Rezoning Transportation Analysis

Petition Number: 2026-023

General Location Identifier: 11304101, 11304606

Date	Description
04-23-26	First Review (CM)
07-09-26	Second Review (TP)

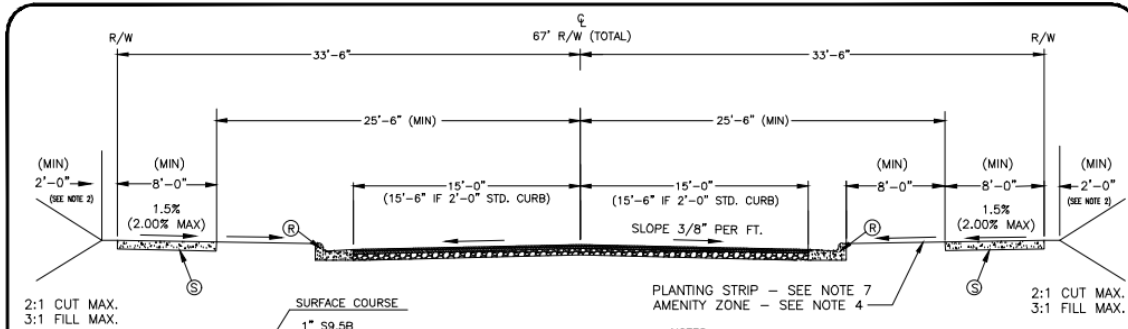
- b. **07-22-26 Outstanding Comment from 04-23-26: Internal Public Local Roads:** Location of future back of curb and gutter to be constructed minimum 17.5ft from centerline of roadway.

Label and dimension the curb and gutter from the centerline for each road on the site plan.

07-22-26 Clarifying Comment: It looks as though the dimensions shown on the public roads are incorrect. Revise dimensions regarding the internal roadway and ensure they match the required back of curb dimensions. Include CLDSM detail for typical section U-07B and U-03 detail on rezoning plan sheet 2 for the internal public roads.

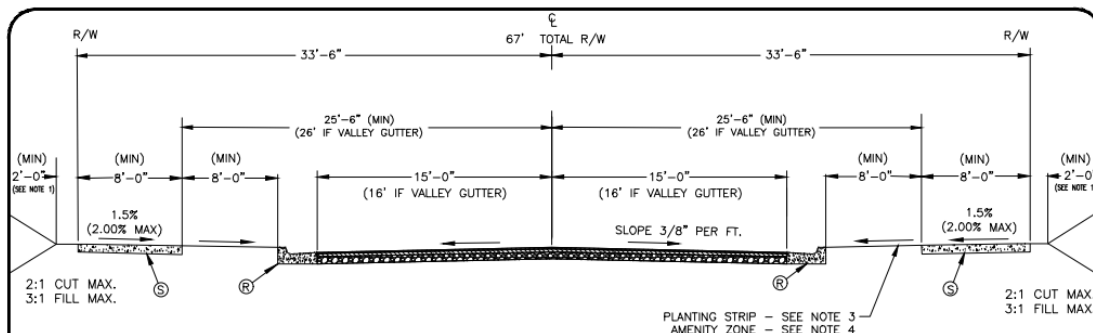
- c. **07-22-26 Outstanding Comment from 04-23-26: Huntwood Drive:** Location of future back of curb and gutter to be constructed minimum 17.5 feet from centerline of roadway.

Label and dimension the curb and gutter from the centerline for each road on the site plan.

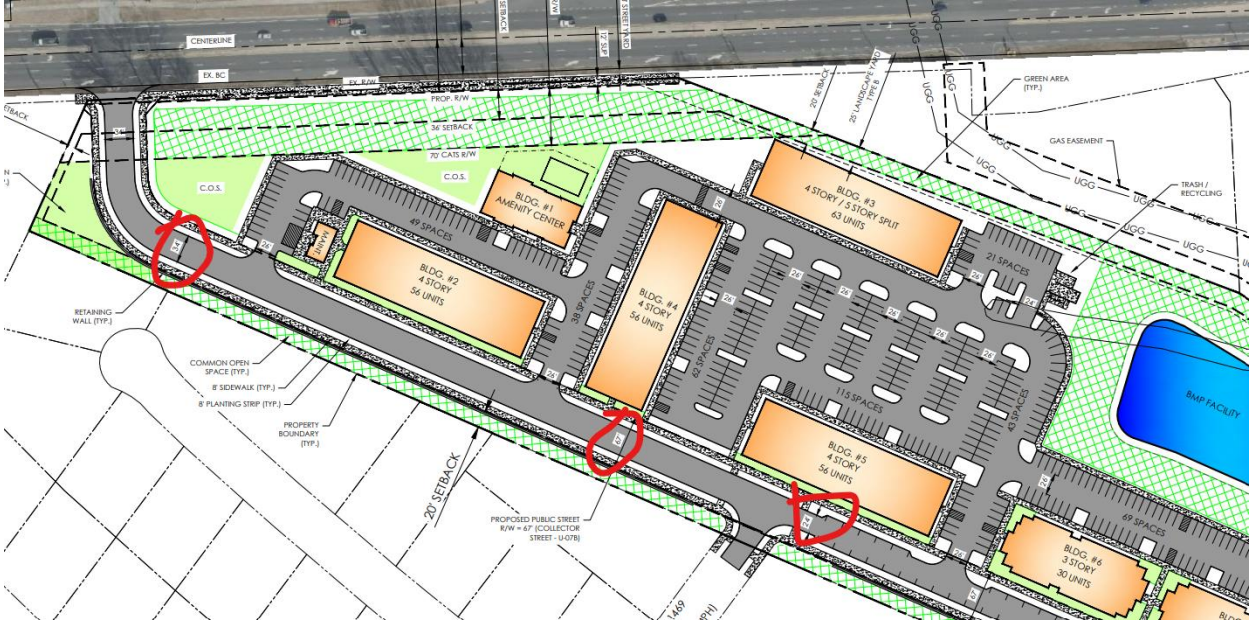
07-22-26 Clarifying Comment: Add a dimension for Huntwood Drive from the roadway centerline to the back of curb location as shown above.
